Stansted Logistics Facility

Wren Kitchens Ltd

Air Quality Addendum

Figure 2: Hatfield Forest Nature Reserve and SSSI

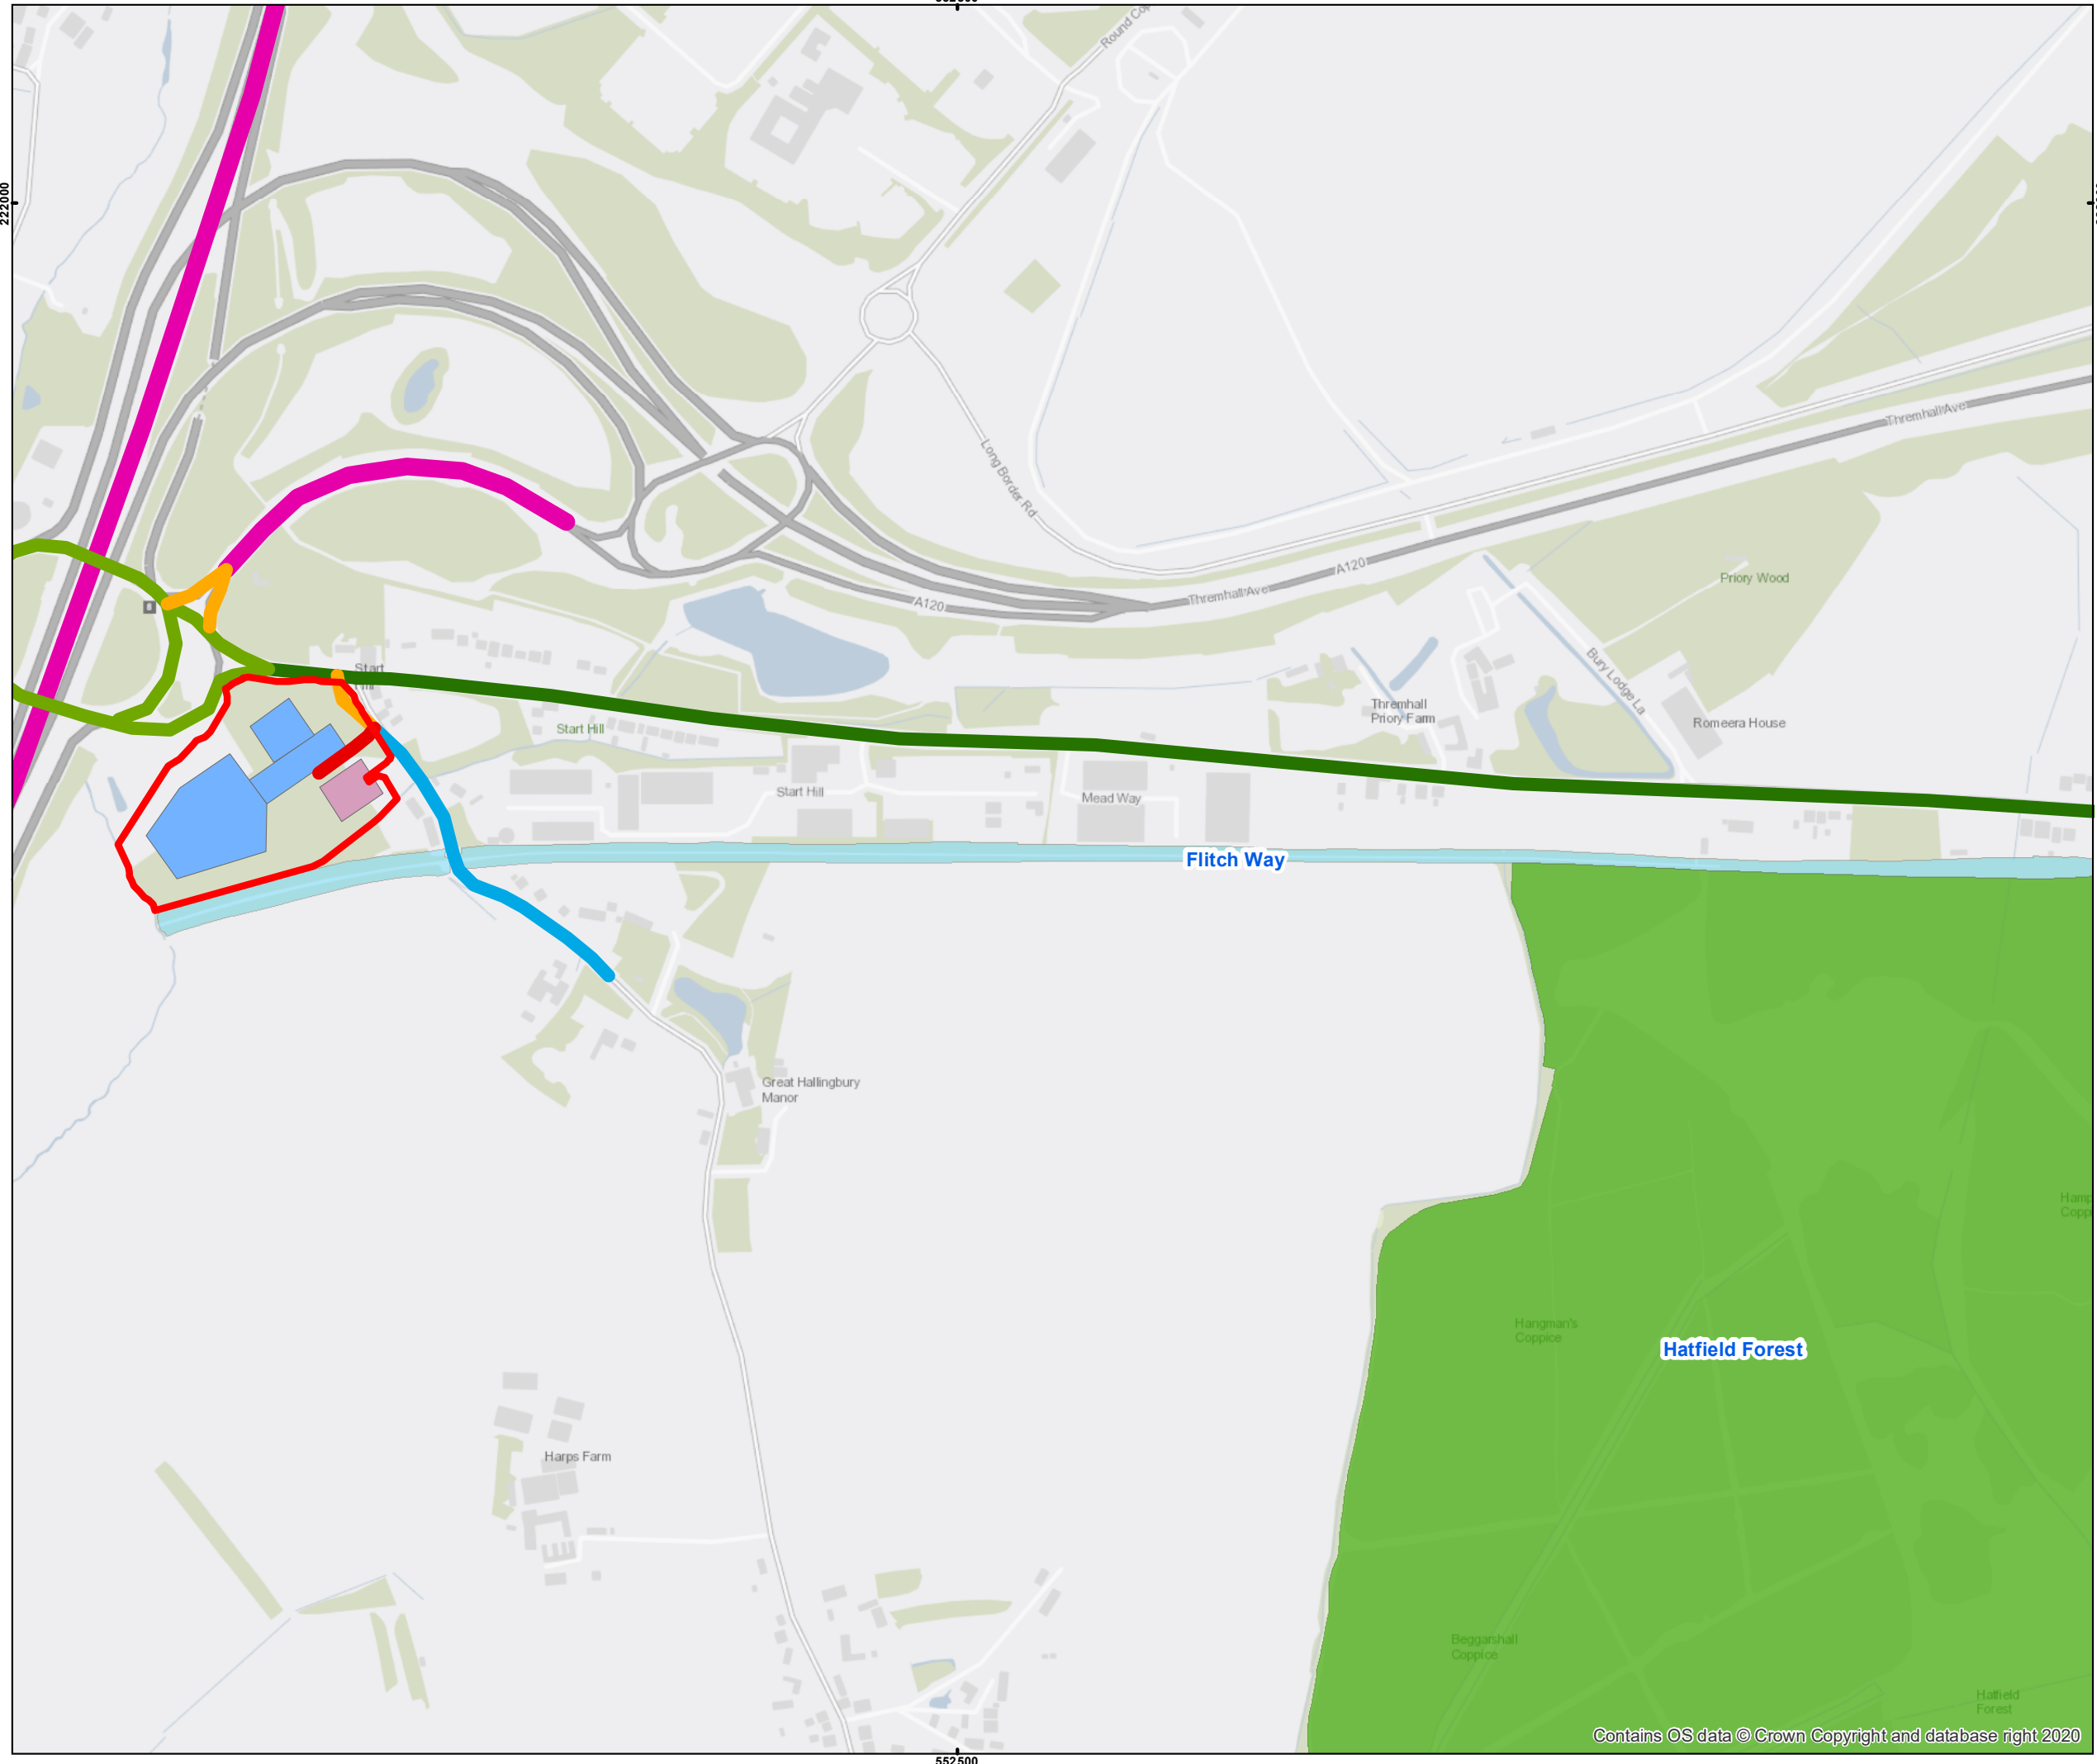
The National Trust's consultation response to application UTT/22/0267/FUL stated:

"... the National Trust are concerned that there is evidence to suggest that the veteran trees and their resident species at Hatfield Forest National Nature Reserve and Site of Special Scientific Interest are sensitive to nutrient enrichment resulting from elevated NOx pollutants from both air and road traffic. Whilst Hatfield Forest is considered within the Ecological Assessment, the National Trust would request that the Local Planning Authority are satisfied that the conclusion that this proposal would not have a "significant adverse effect on the statutory site due to the nature of development (non-residential) and the intervening distances" is an appropriate conclusion, prior to the determination of this proposal."

Section 5.2 of Original AQA states the screening criteria for determining the requirement for an assessment of air quality effects on ecological sites. Only ecological sites within 200 m of a road affected by the Proposed Development require consideration. As shown on Figure 2 of Appendix A, the Hatfield Forest Nature Reserve and SSSI lies over 1 km from the Proposed Development. Although the Hatfield Forest Nature Reserve and SSSI lies within 200 m of the B1256 to the east of the Proposed Development (around 60 m at the closest point), the Proposed Development will result in only 13 daily car trips along this road, the effect of which was screened out of the assessment due to the very low number of vehicles.

Although the Hatfield Forest Nature Reserve and SSSI was not screened into the assessment, consideration has been given to the potential magnitude of the impact. The Flitch Way Local Nature Reserve (LNR) does lie within the screening distance of the Proposed Development, so was included in the Original AQA.

The LNR lies within 20 m of the Proposed Development boundary at the closest point. The Original AQA showed that the nutrient nitrogen deposition impact of the Proposed Development on the LNR was only just over the 1% screening threshold, at a maximum of 1.56% of the Critical Load for woodlands. Although this impact cannot be screened out as 'insignificant', the ecologist for the project assessed the significance of effect as 'not significant'. Given the very small impact on the LNR at a distance of 20 m, the impact on the Hatfield Forest Nature Reserve and SSSI at over 1 km distant from the Proposed Development, and 60 m distant from the very low level of additional traffic on the B1256, would be imperceptible. Therefore, the effect on ecological features will be 'not significant'.
